Title of Change:	Product Discontinuance Notification - New package introduction
Last Time Buy Date:	13 May 2021
Last Ship Date:	13 Nov 2021
Contact information:	Contact your local ON Semiconductor Sales Office or Yuna.Im@onsemi.com
Type of notification:	Customers must notify ON Semiconductor (< PCN.Support@onsemi.com >) in writing within 90 days of receipt of this notification if they consider the discontinued product to be "Sole Source." ON Semiconductor and the customer may negotiate an appropriate End-of-Life.

文書番号: PD23009X

発行日: 13 Nov 2020

TO-220 FULLPACK, 3-LEAD
CASE 221BN
ISSUE O

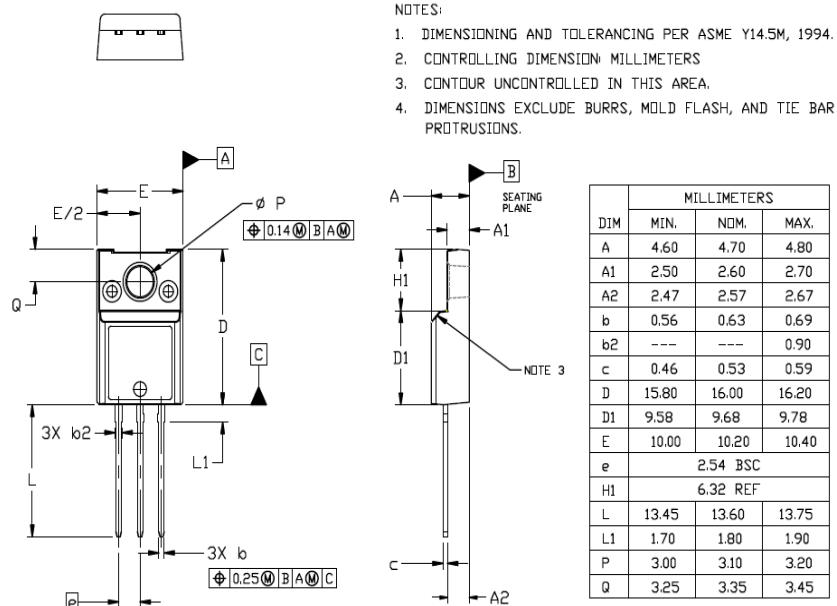
As a result of the discontinuation of Samsung mold compound SG8300HK, the replacement mold compound is being introduced along with a change to the package outline, adopting an improved ultra-narrow TO220FP package outline providing improvements for customer PCB design applications due to narrower pin dimension. Also enables manufacturing expansion for capacity improvement.

Symbol (Follow Case # 221BN)	From Case# 340BF		To Case # 221BN	
	MIN (mm)	MAX (mm)	MIN (mm)	MAX (mm)
A	4.30	4.60	4.60	4.80
A1	2.50	2.90	2.50	2.70
A2	2.30	2.70	2.47	2.67
b	0.50	0.90	0.56	0.69
b1	0.90	1.20	-	-
b2	1.00	1.20	-	0.90
c	0.40	0.60	0.46	0.59
D	15.00	15.70	15.80	16.20
D1	-	-	9.58	9.78
E	9.80	10.30	10.00	10.40
e	2.34	2.74	2.54 BSC	
H/H1	6.20	6.60	6.32 REF	
L	10.30	10.70	13.45	13.75
L1	2.70	3.30	1.70	1.90
L2	17.70	19.00	-	-
ØP	3.00	3.40	3.00	3.20
Q	2.60	3.00	3.25	3.45
θ	45°		-	
J	N/A		-	
K	N/A		-

パッケージアウトライン図:

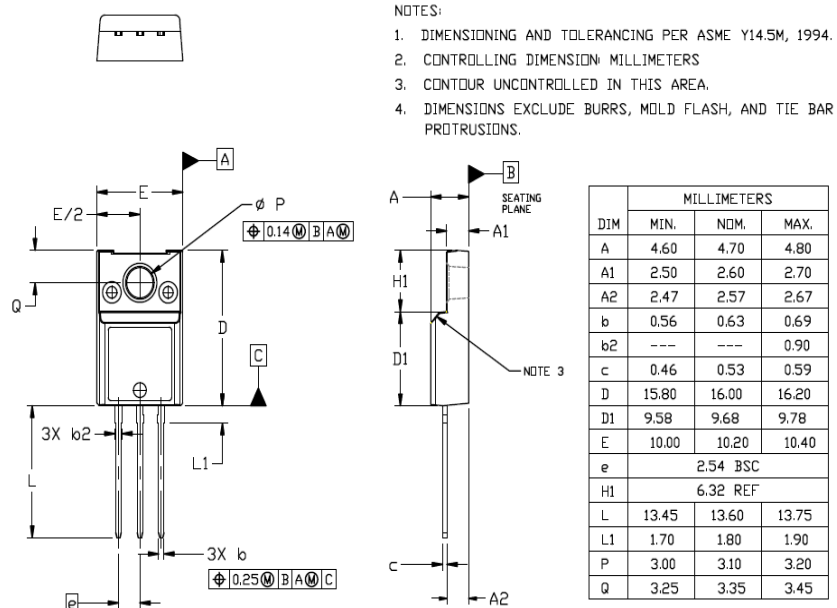
Samsung モールドコンパウンド SG8300HK の廃止に伴い、パッケージアウトラインを変更して、狭いピン寸法のためお客様の PCB 設計アプリケーションを向上させる改良した ultra-narrow TO220FP パッケージアウトラインを採用する代替のモールドコンパウンドを導入します。また、生産能力の向上のために製造を拡大することも可能になります。

記号 (ケース # 221BN に従う)	変更前 ケース # 340BF		変更後 ケース # 221BN	
	MIN (mm)	MAX (mm)	MIN (mm)	MAX (mm)
A	4.30	4.60	4.60	4.80
A1	2.50	2.90	2.50	2.70
A2	2.30	2.70	2.47	2.67
b	0.50	0.90	0.56	0.69
b1	0.90	1.20	-	-
b2	1.00	1.20	-	0.90
c	0.40	0.60	0.46	0.59
D	15.00	15.70	15.80	16.20
D1	-	-	9.58	9.78
E	9.80	10.30	10.00	10.40
e	2.34	2.74	2.54 BSC	
H/H1	6.20	6.60	6.32 REF	
L	10.30	10.70	13.45	13.75
L1	2.70	3.30	1.70	1.90
L2	17.70	19.00	-	-
ØP	3.00	3.40	3.00	3.20
Q	2.60	3.00	3.25	3.45
θ	45°		-	
J	N/A		-	
K	N/A		-
